ADA Curb Ramp New Construction Inspection Form (Perpendicular)

NW 309th Ave

24952.54

NW Timeric Dr

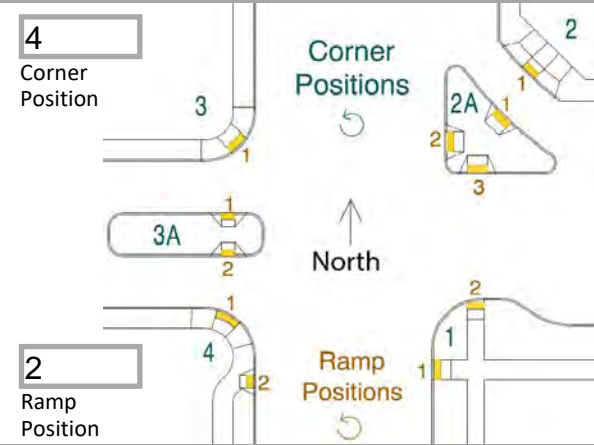
Failure, poor craftsmanship, warped turn
space
